# HISTORIC DISTRICT COMMISSION AGENDA June 6, 2018 CITY COUNCIL CHAMBERS 5:00 p.m. 50 Natoma Street Folsom, California 95630

#### 1. PN 18-129, 916 Figueroa Street Duplex Design Review and Determination that the Project is Exempt from CEQA

#### HISTORIC DISTRICT COMMISSION STAFF REPORT

**PROJECT TITLE:** 916 Figueroa Street Duplex

Building Elevations dated May 25, 2018

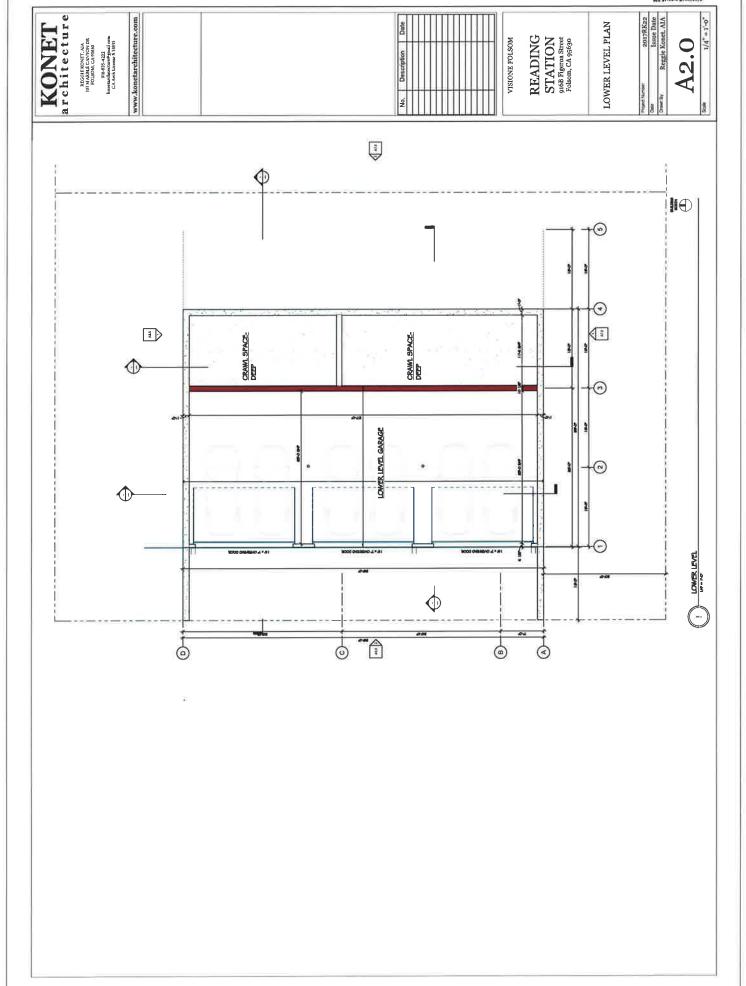
The Folsom Heritage Preservation League (HPL) provided staff with a comment letter based on the plans that were submitted. This letter is included in Attachment No. 10. The HPL recommended that the application be denied. This recommendation is based on the assertion that the garage doors would not be concealed from view from Reading Street due to the slope of the street. The HPL also stated that Greek Revival building design has not been previously used in the Figueroa Subarea (though it is in the appropriate timeframe) and that the project does not include features that often are included with this style, including defined upper gables (separated from the remaining façade by a cornice and trim), two-story-high columns (or faux, façade mounted pilasters), and tall narrow windows.

In response to the garage concerns, staff refers to the "Attached Garage" section above. Based on this analysis, staff concludes that the garage doors will not be visible from Reading Street. Regarding Greek Revival architecture, staff has addressed this in the "Building Design and Architecture" section above. Staff shared the HPL's letter with the applicant. The applicant agreed to add the following elements to the design:

- 5. The garage door windows and panels shall be removed and hinges and handles shall be added to the garage door so that it resembles two carriage-style doors. This revision shall be made to the plans submitted for a Building Permit to the satisfaction of the Community Development Department.

- Adding narrow, taller windows on all elevations
- Adding additional columns on the porches on the south elevations
- Widening the two garage doors and eliminating the entry between the garage doors
- Incorporating a pediment gable roof at the South and East elevations

These modifications have been incorporated into the elevations included in this staff report as Attachment No. 5.
